RIVERVIEW FARM ESTATES SUBDIVISION

APPLICATION NUMBER 15 DATE August 6, 2015

REQUEST Subdivision

DETAIL SITE PLAN

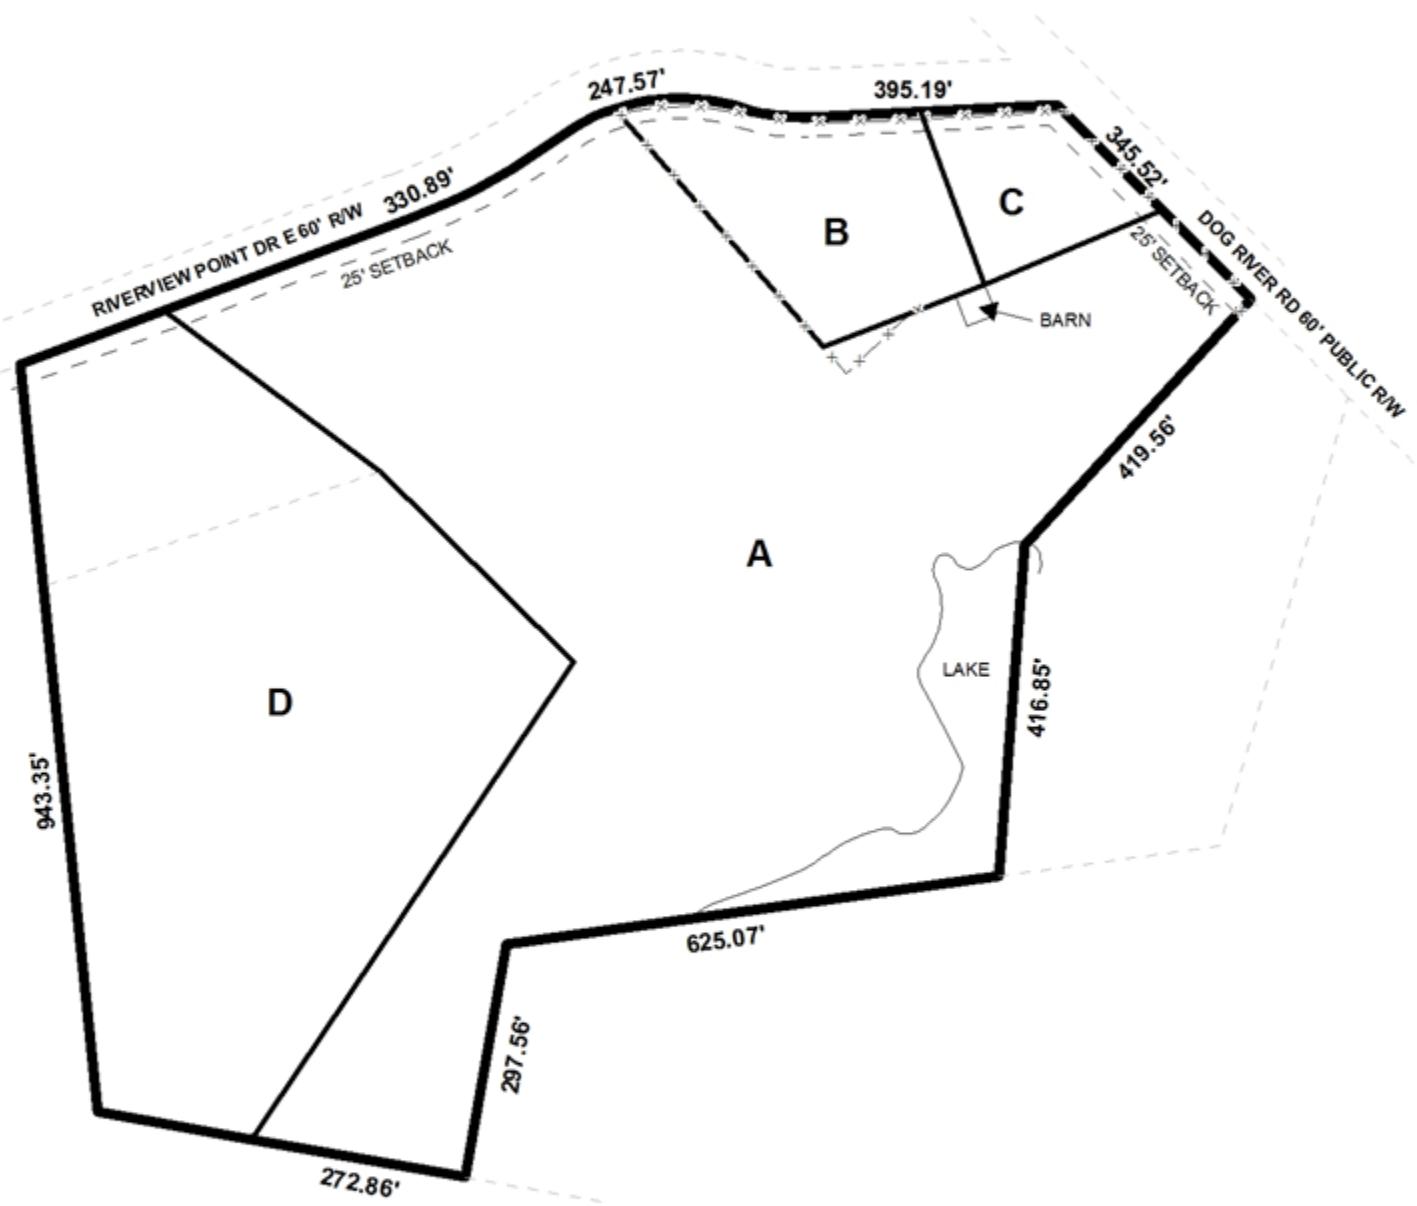
As on the preliminary plat, the 25' minimum building setback line should be illustrated along both street frontages. And as on the preliminary plat, each lot should be labeled with its size in both square feet and acres, or a table should be furnished on the Final Plat providing the same information.

Lots A and D would exceed the maximum depth-to-width ratio allowed by Section V.D.3. of the Subdivision Regulations; however, this is common of other lots approved by the Commission within the area and a waiver of this section would seem in order.

- 1) placement of a note on the Final Plat stating that Lot A is limited to two curb cuts to Riverview Pointe Drive, and Lots B, C and D are each limited to one curb cut to Riverview Pointe Drive, with the size, design and location of all curb cuts to be approved by Mobile County Engineering and conform to AASHTO standards;

- 2) retention of the 25' minimum building setback line along all street frontages;
- 3) labeling of each lot with its size in both square feet and acres, or the furnishing of a table on the Final Plat providing the same information;
